STAFF REPORT

Community Development | Board of Zoning Appeals

Applicant	Scott Webb, Architect
Location	327 W Spring Street
Owner	Miami Mobile Home Park LLC, c/o Gail J. Willis
Action Request	Variances to Section 1141.04(j)(3)(G) trash enclosure location; Section 1149.07(b)(1) parking spaces in front setback; Section 1149.07(b)(3) maximum parking in front of structure; and Section 1149.07(e)(2) requirement for one loading space
Lot Size	18,887 sq ft approx.
Lot Width	129 ft approx. on W Spring Street; 146 ft approx. on S Locust Street;
Building Size	2,400 sq ft
Current Use	Commercial (Vacant) – former gas station & convenience store
Current Zoning	GB General Business District
Surrounding Land Uses	Multi-family apartment complex (South Locust Apartments) to the south; commercial to the east (formerly PEAK Health & Nutrition); electric substation to the north; commercial gas station (Speedway) to the west

RE: Preliminary Zoning Review for 327 W Spring – Change of Use to Restaurant

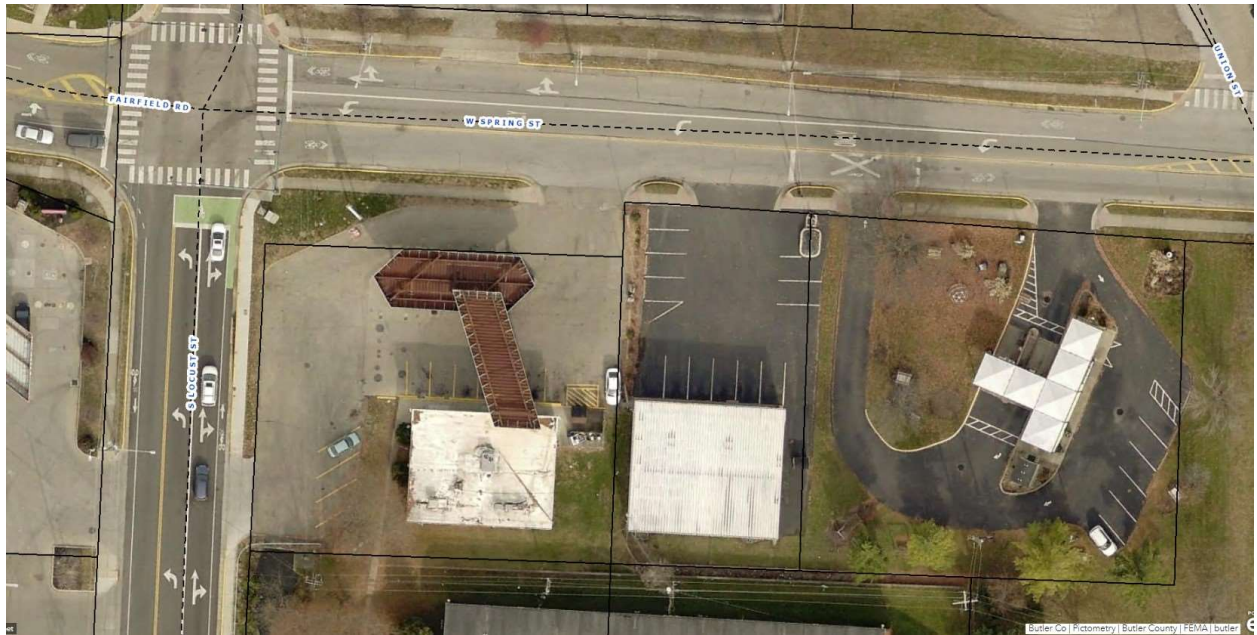
Existing Building showing existing trash area to be relocated.
